Technical Service Bulletin

SUBJECT:		No:	TSB-19-23-006
UPDATES TO MAINTENANCE & ASSEMBLY PROCEDURES FOR CVT F1CJB - SERVICE MANUAL REVISION		DATE:	June 2019
		MODEL:	2014-19 Mirage, 2017-19 Mirage G4
CIRCULATE TO:	<input type="checkbox"/> GENERAL MANAGER	<input checked="" type="checkbox"/> PARTS MANAGER	<input type="checkbox"/> TECHNICIAN
<input checked="" type="checkbox"/> SERVICE ADVISOR	<input checked="" type="checkbox"/> SERVICE MANAGER	<input type="checkbox"/> WARRANTY PROCESSOR	<input type="checkbox"/> SALES MANAGER

This TSB updates the Automatic Transaxle section of the affected Service Manuals to update procedures for CVT F1CJB, including diagnosis, maintenance, and transaxle disassembly and reassembly. Changes have been made to procedures due to the following parts being established as service parts:

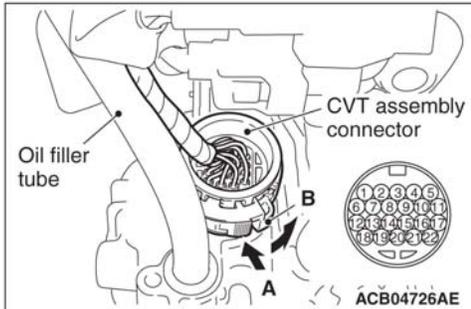
3. When the resistance is outside the standard value, replace the transaxle assembly.

<New>

valve body

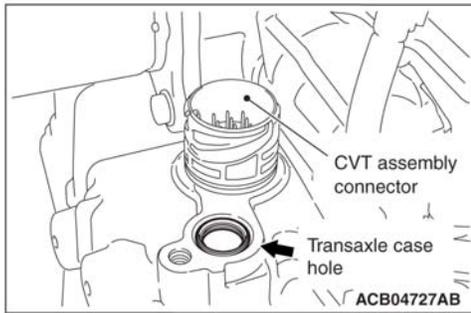
4. When the resistance of the transmission fluid temperature sensor is outside the standard value, and the fluid temperature warning comes on/goes out at other than the specified temperatures, replace the **transaxle** assembly.

TRANSAXLE

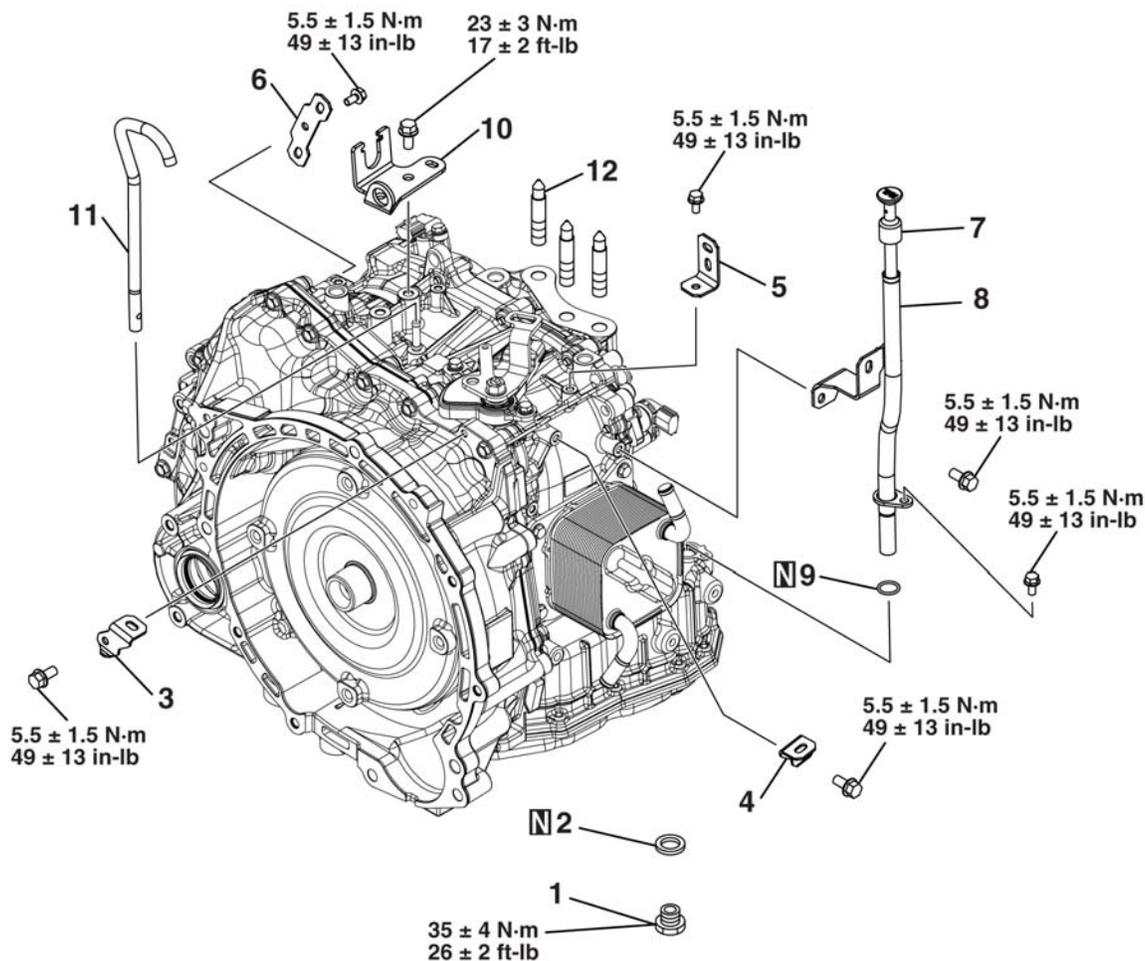
Please **REPLACE** the following information in the **2014 - 2015 Mirage** Service Manuals, Group 23-Automatic Transaxle -> 23B-Continuously Variable Transaxle Overhaul -> Transaxle -> Disassembly and Reassembly.

**CONTINUOUSLY VARIABLE TRANSAXLE OVERHAUL
 TRANSAXLE**

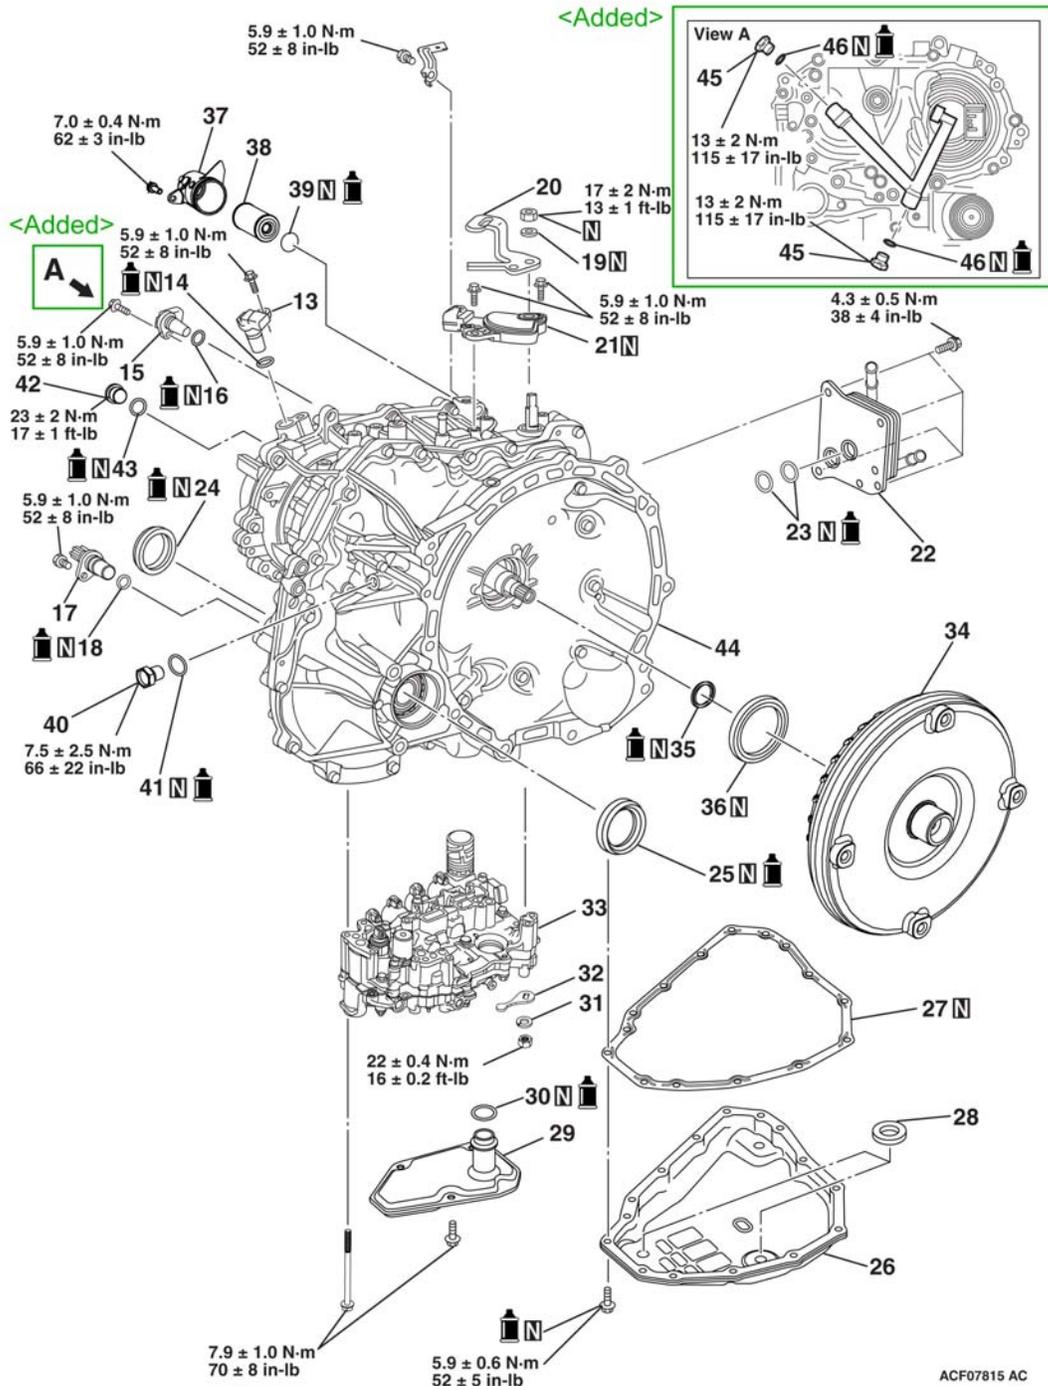
Please **REPLACE** the following information in the **2014, 2015, 2017 - 2019 Mirage and 2017 - 2019 Mirage G4** Service Manuals, Group 23-Automatic Transaxle -> 23B-Continuously Variable Transaxle Overhaul -> Transaxle -> Disassembly and Reassembly.
